## SERVISNÍ BULLETIN č. 54 rev. 1

- 1. TÝKÁ SE:** Palivové lahve CB2990 (Alugas) výrobce Cameron Balloons Ltd.
- 2. DŮVOD:** Praskliny ve svarech u hliníkových lahví CB2990 (Alugas) –únik paliva.  
Bylo vydáno AD č. G-2022-0010-E (<https://ad.easa.europa.eu/ad/G-2022-0010-E>)

# Alert Service Bulletin No 33

(a) No.:	33
(b) Revision / Date	0 / 04 March 2022
(c) Title:	ALUGAS Cylinders - Temporary withdrawal from service
(d) Description:	Temporary withdrawal from service of CB2990 (Alugas) cylinders
(e) Applicability:	All hot-air balloons (from all manufacturers) fitted with CB2990 (Alugas) cylinders
(f) Effectivity:	Fuel cylinders Part Number CB2990 (Alugas) cylinders having serial numbers:  OC25001 to OC25202 QI14001 to QI14494  Note: This serial number range covers all CB2990 (Alugas) cylinders currently in service.  These fuel cylinders are known to be installed on, but not limited to, hot-air balloons and airships manufactured by Cameron Balloons Ltd, Colt Balloons, Lindstrand Balloons Ltd (LBL), Lindstrand Hot Air Balloons Ltd, Sky Balloons, Thunder Balloons, and Thunder & Colt

Figure 1 - Section indicating Valve Plate

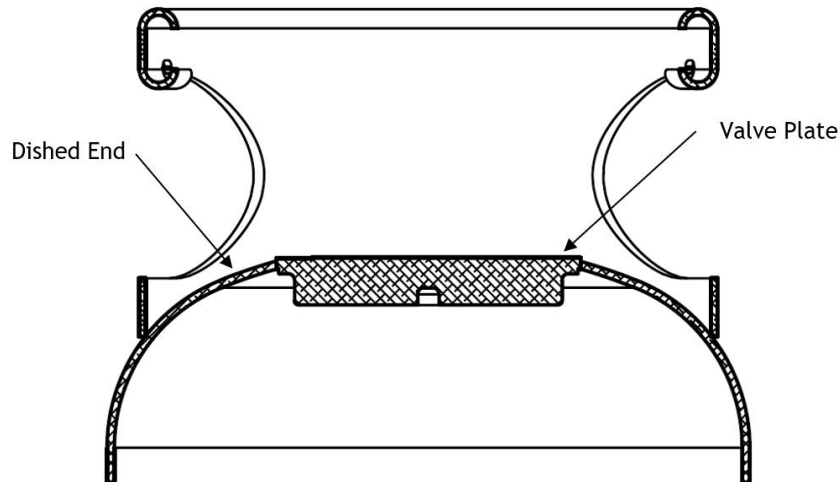
Five CB2990 (Alugas) cylinders have developed cracks in the weld between the cylinder valve plate and the upper dished end. These cracks allow the release of propane from the cylinder. Failures have been observed during periodic inspection (hydraulic pressure test), and leak test. All the in-service failures seen to date have been from the batch of cylinders with serial numbers starting OC.

Within 24 hours of receipt of this bulletin affected cylinders must be checked for leaking around the interface between the cylinder valve plate and the upper dished end using leak detector fluid. Any cylinders found to be leaking must be emptied of fuel immediately. A pilot may carry out this inspection. A satisfactory leak check **does not** release the cylinder to service.

Within 7 days of receipt of this bulletin affected cylinders must be emptied of fuel.
